City of Tualatin

NOTICE OF ARCHITECTURAL REVIEW BOARD DECISION

Case #: AR-13-07
Project: Nyberg Rivers Shopping Center
Location: 7455 - 7925 SW Nyberg Road (Tax Map 2S1 24 A, Tax Lots 1601, 1602, 1900, 2502, 2506, 2507, 2508, and 2700; Tax Map 2S1 24B, Tax Lots 2000, 2001, and 2100)
Applicant: Michael Kirk, CenterCal (503-968-8940)
Michael Cerbone, Cardno (503-419-2500)
Property Owner: Tuala Northwest, LLC, Dean McBale, George A. Gill, and ODOT

Cabela's Rear Elevation Enhancements--Tualatin

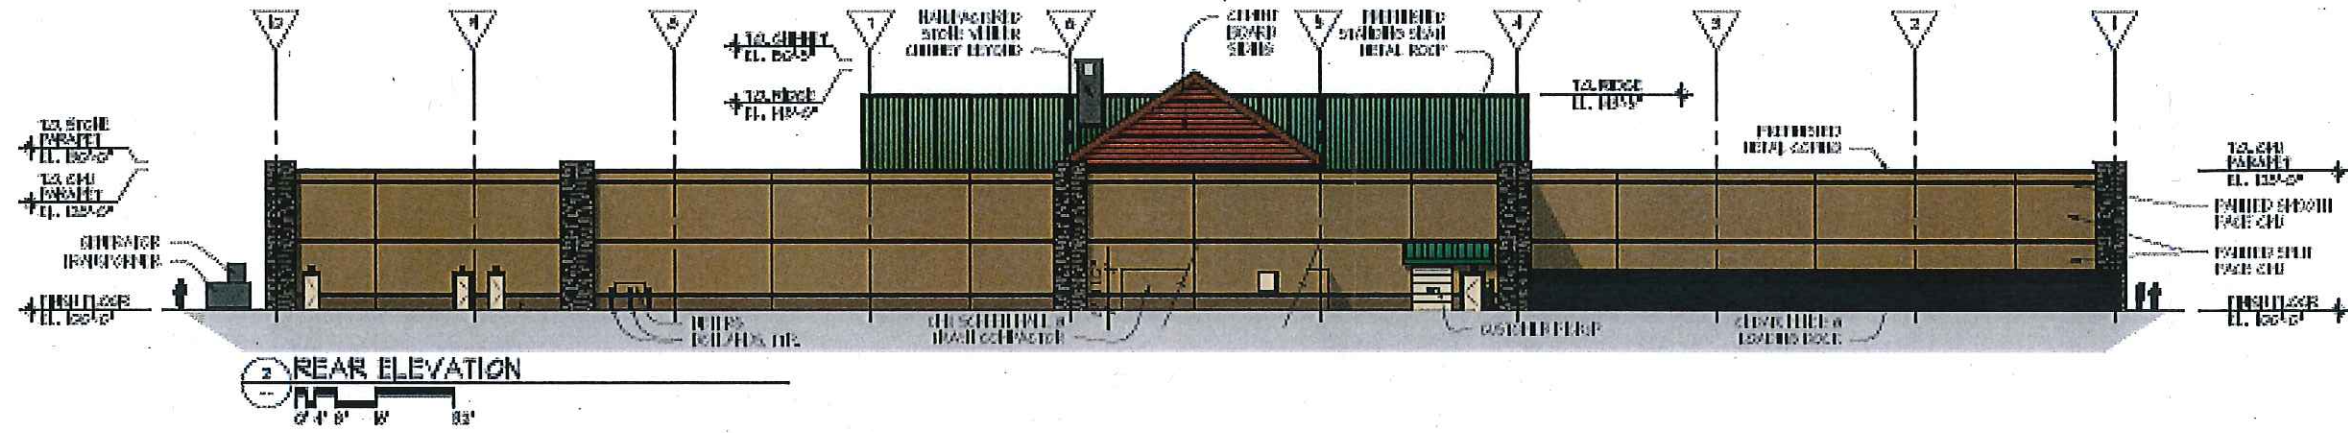
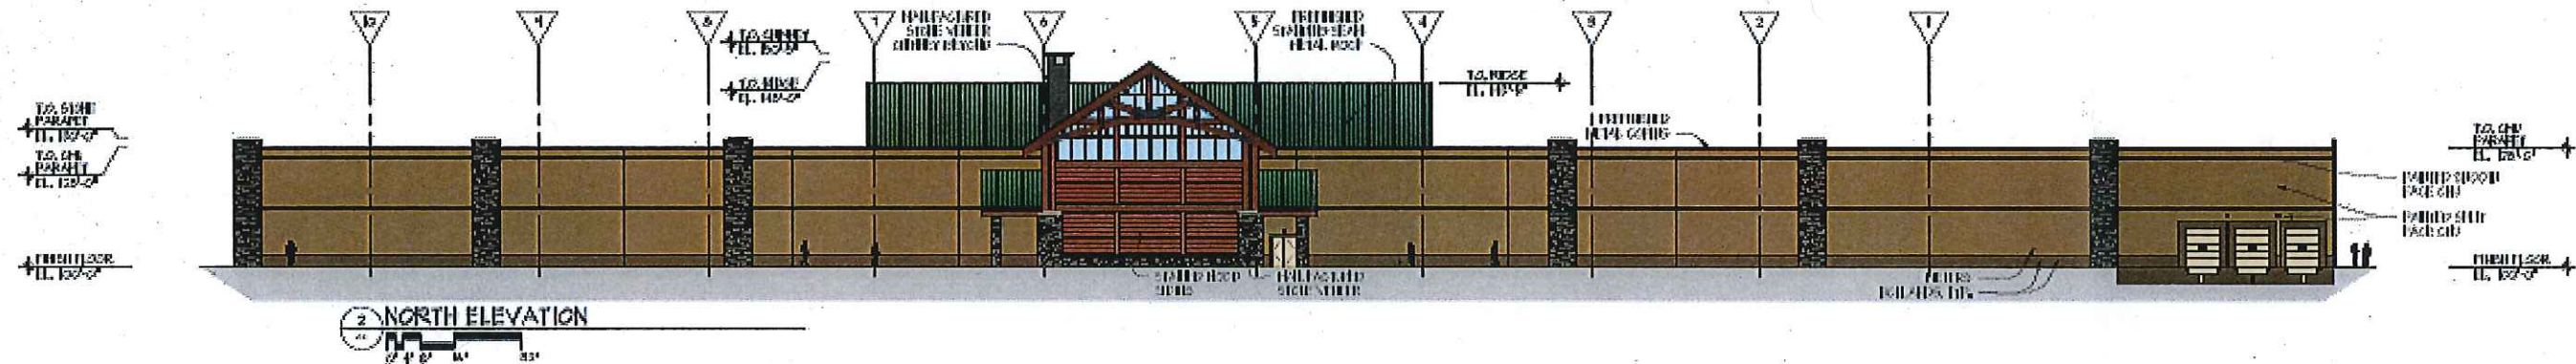
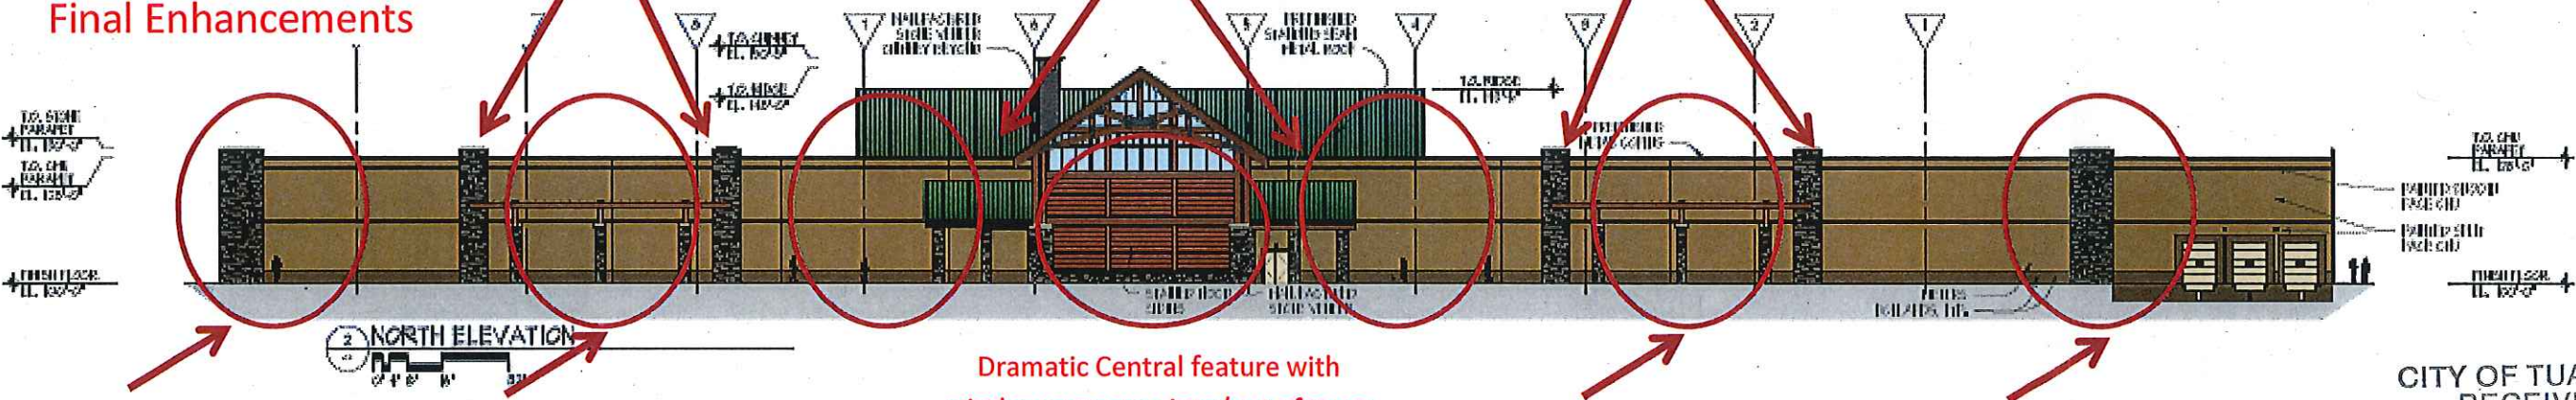
"The applicant shall construct the west elevation (along the pedestrian walkway) of Cabela's including the stone veneer and wood screen wall with the architecture proposed on page

5.3 and 5.4 of the December 9th submittal booklet. The applicant shall also add the architectural features shown in the picture below to all sides and all corners of the building as proposed during the master plan. The applicant shall also add all architectural features shown on page 30 of the December 3rd presentation to the Architectural Review Board. In addition the Cabela's building shall also add the trellises shown on the north side of Cabela's on page A3.10a of the complete plan set intake stamped date November 12, 2013 to the south side of the building. These trellises shall be 62-feet wide, 18-feet in height, and have three stone veneer columns exactly like the trellises shown on the north side of the building. The applicant shall also screen the trash compacter with the exact same treatment as the proposed Cabela's loading dock screen wall shown on page 5.3 and 5.4 of the December 9th submittal booklet."

5. The applicant shall construct the west elevation (along the pedestrian walkway) of Cabela's including the stone veneer and wood screen wall with the architecture proposed on page 5.3 and 5.4 of the December 9th submittal booklet. The applicant shall also add the architectural features shown in the picture below to all sides and all corners of the building as proposed during the master plan. The applicant shall also add all architectural features shown on page 30 of the December 3rd presentation to the Architectural Review Board. In addition the Cabela's building shall also add the trellises shown on the north side of Cabela's on page A3.10a of the complete plan set intake stamped date November 12, 2013 to the south side of the building. These trellises shall be 62-feet wide, 18-feet in height, and have three stone veneer columns exactly like the trellises shown on the north side of the building. The applicant shall also screen the trash compactor with the exact same treatment as the proposed Cabela's loading dock screen wall shown on page 5.3 and 5.4 of the December 9th submittal booklet.

Architecture on Cabela's

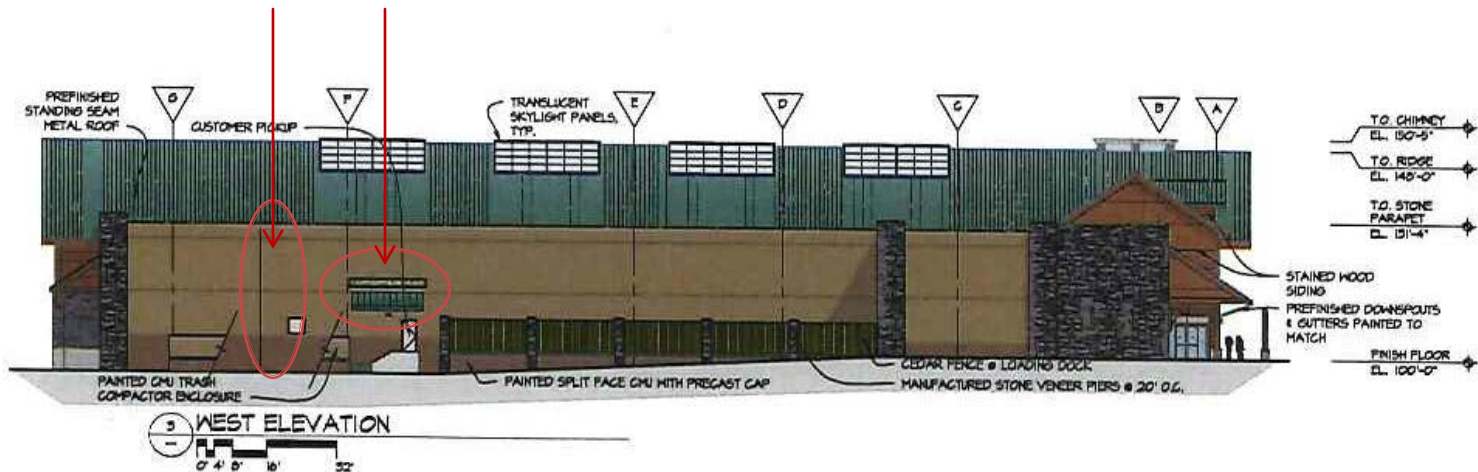
The applicant shall also add the architectural features shown in the picture below to all sides and all corners of the building as proposed on during the master plan on Exhibit P of the June 3 Addendum.

Architecture on Cabela's

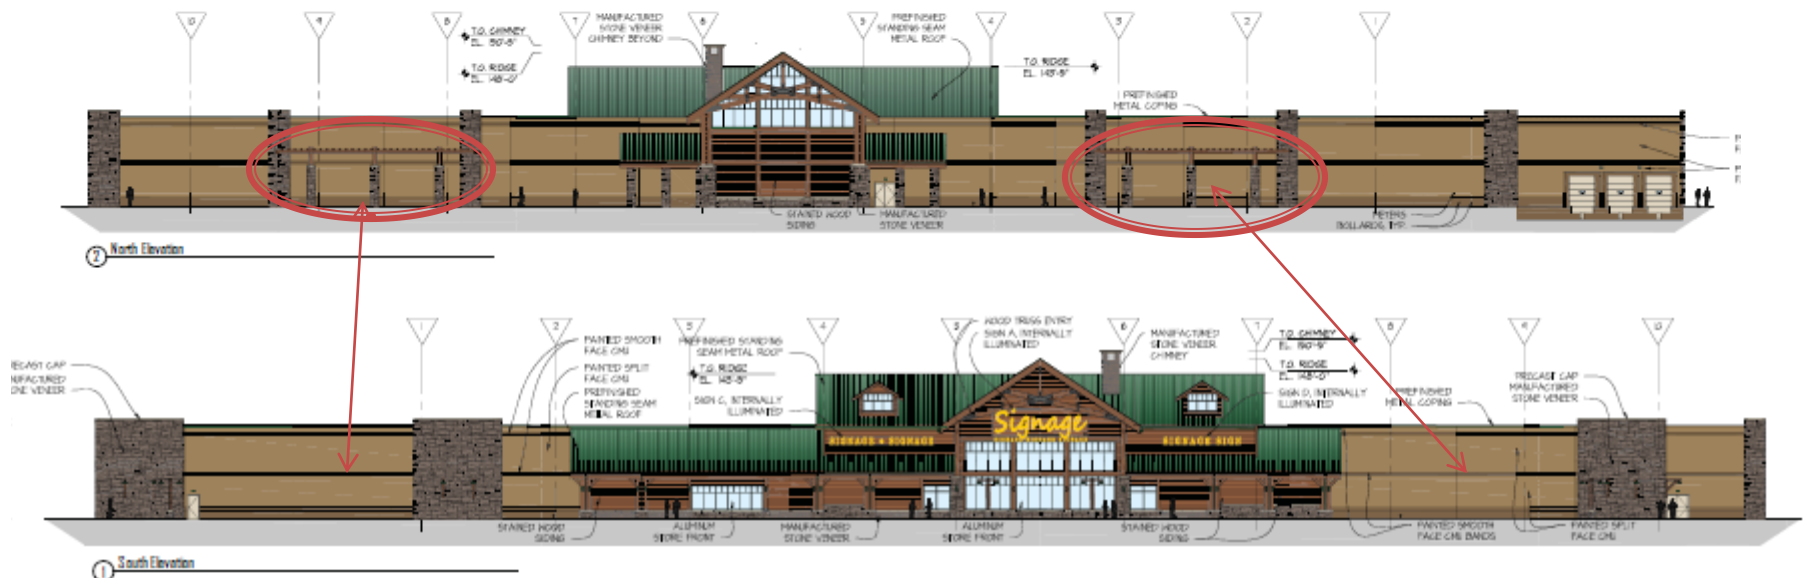
In addition the Cabela's building shall also add the trellises shown on the north side of Cabela's on page A3.10a of the complete plan set intake stamped date November 12, 2013 to the south side of the building. These trellises shall be 62-feet wide, 18-feet in height, and have three stone veneer columns exactly like the trellises shown on the north side of the building.
